CCB 6792
Pre and Post Change Summary
PCN #: GDOS-04EWFZ700

Pre and Post Change Summary - Lead Frame Comparison

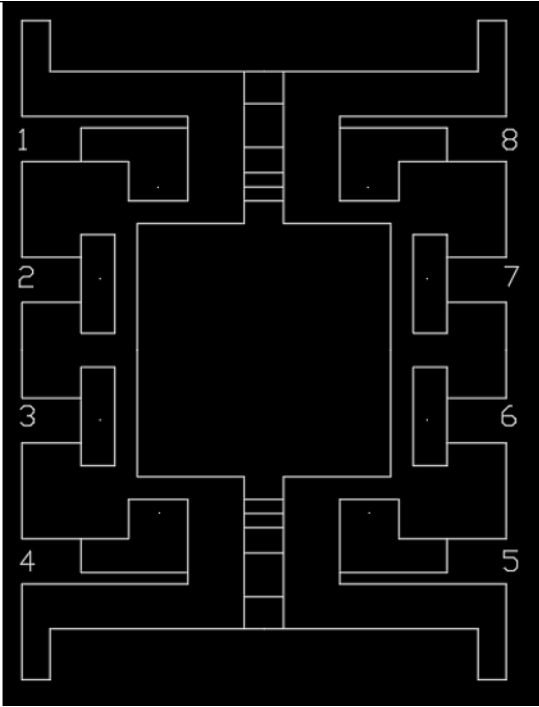
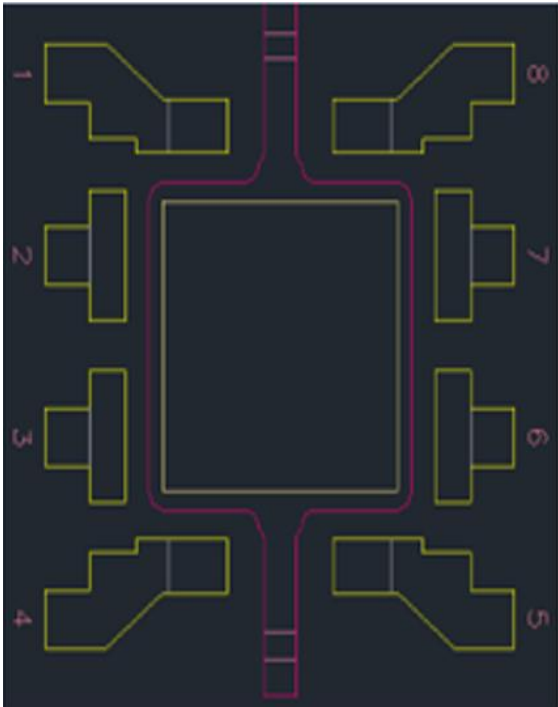
ASSH		MTAI	
 <p>A schematic diagram of the ASSH lead frame. It shows a central square die area with eight leads extending outwards. The leads are numbered 1 through 8, starting from the top-left and moving clockwise. The leads have a complex, stepped profile.</p>		 <p>A schematic diagram of the MTAI lead frame. It shows a central square die area with eight leads extending outwards. The leads are numbered 1 through 8, starting from the top-left and moving clockwise. The leads have a simpler, more rectangular profile compared to the ASSH version.</p>	
Lead frame material	C194	Lead frame material	C194
DAP Surface Prep	PPF	DAP Surface Prep	Bare Cu
Lead Plating	NiPdAu	Lead Plating	Matte tin
